TOWNES OF MAIN STREET JSP 20-35

Public hearing at the request of Singh Development for JSP 20-35 Townes of Main Street for recommendation to the City Council for approval or denial of Preliminary Site Plan, Phasing Plan, Wetland Permit, and Storm Water Management Plan. The subject property is zoned TC-1 (Town Center One) and is approximately 17.7 acres. It is located north and south of Main Street, east of Novi Road, in Section 23. The applicant is proposing a multifamily development with 192 townhouse-style apartments. The site improvements include a private street network, surface parking, and related open space amenities. The applicant is proposing construction in three phases.

Planning Review
Townes at Main Street
JSP 20-35

2nd Revised Preliminary Site Plan

Figure 1

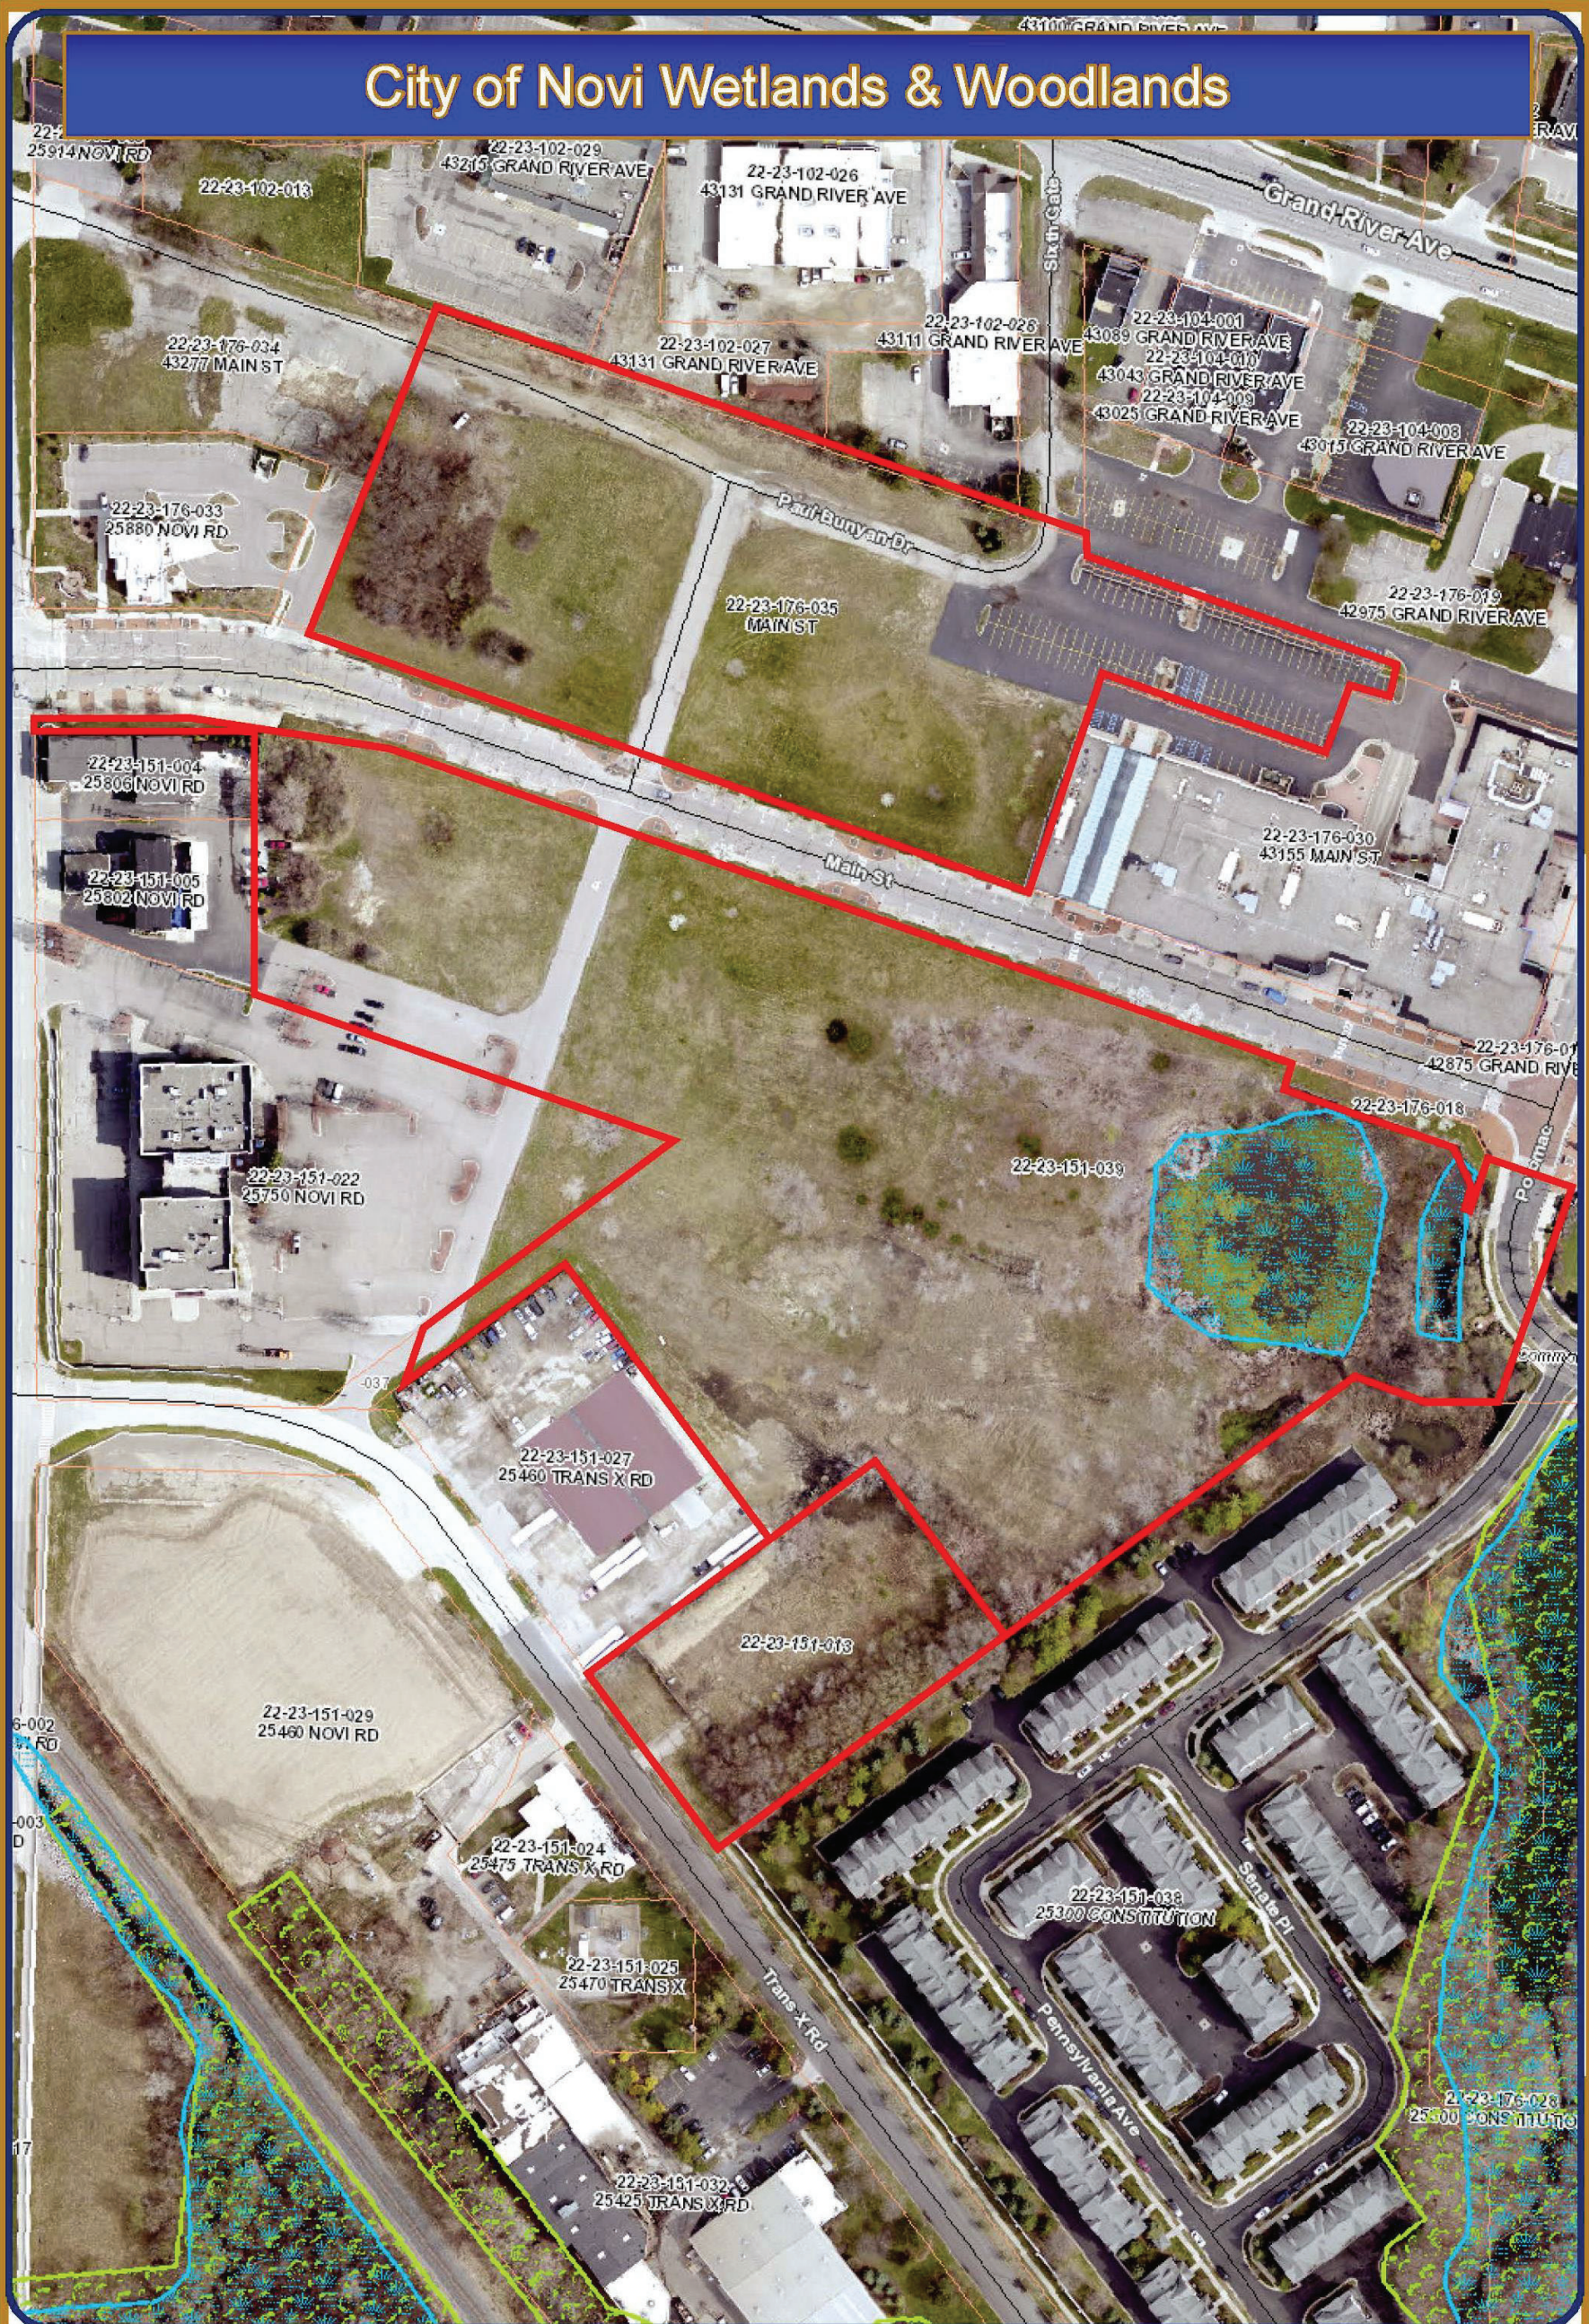
MSG reviewed The City of Novi Wetlands Maps and the Michigan Department of Environment, Great Lakes, and Energy (EGLE) Wetlands Map Viewer for the project site. The project site contains a portion of a City of Novi Regulated Wetland near the eastern-central limit of Parcel 2, where a storm water detention basin is located (Figure 1). Wetland (hydric) soils are also identified by EGLE on the Part 303 Wetlands Inventory at and around the storm water detention basin (Figure 2). Other wetland conditions are not identified by the City of Novi or EGLE at the Site.

Figure 4 City of Novi historical aerial image (1949). Approximate Site boundary is shown in red.

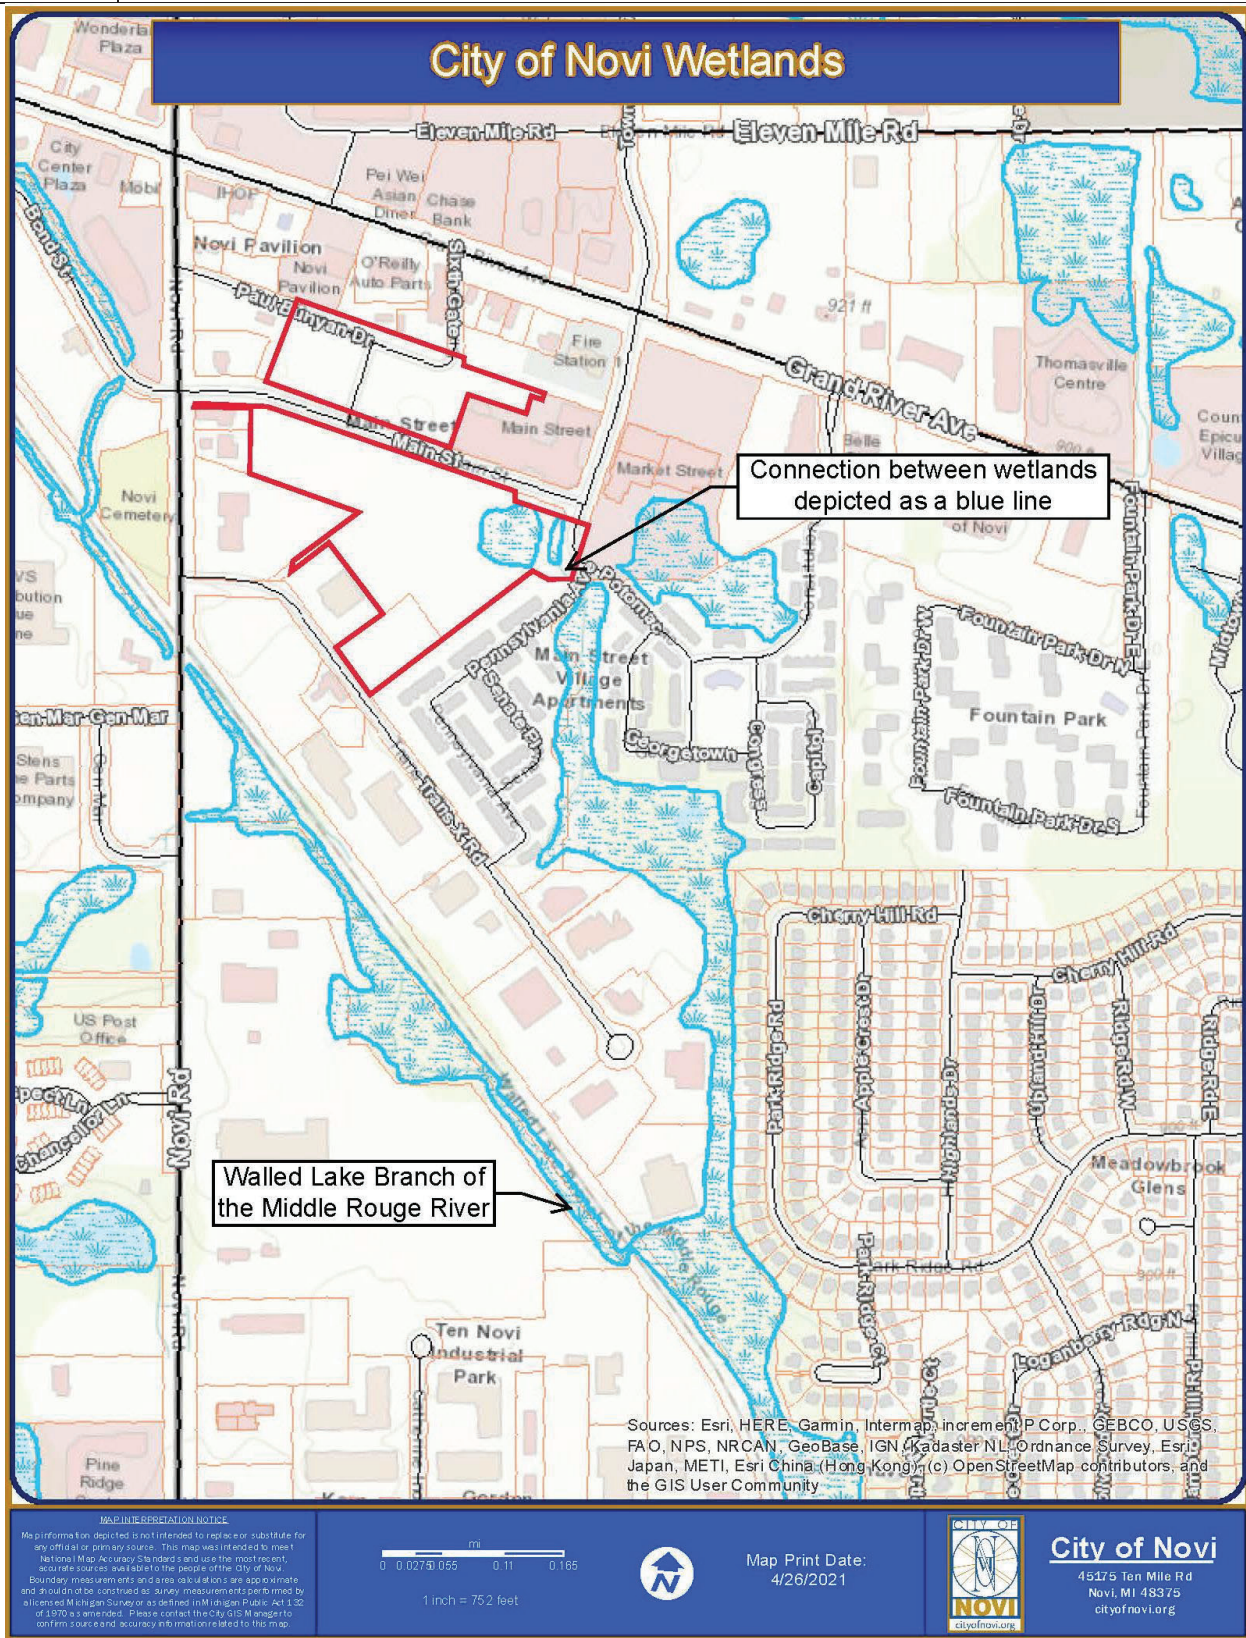
- Based on the City of Novi Wetlands Maps and the PSP, it appears the storm water detention basin (a.k.a. Wetland L) is directly connected to a tributary of the Walled Lake Branch of the Middle Rouge River (Figure 3).
- Based on MSG's review of historical aerial images of the Site, the detention basin is not a recently engineered feature. The current basin appears to be a natural formation that has been present and in communication with Walled Lake Branch of the Middle Rouge River since at least the 1940s (Figure 4).
- In addition, Wetlands M through Q are within 500 feet of the detention basin.
- Therefore, it appears likely all of the identified wetland areas would be regulated by EGLE.
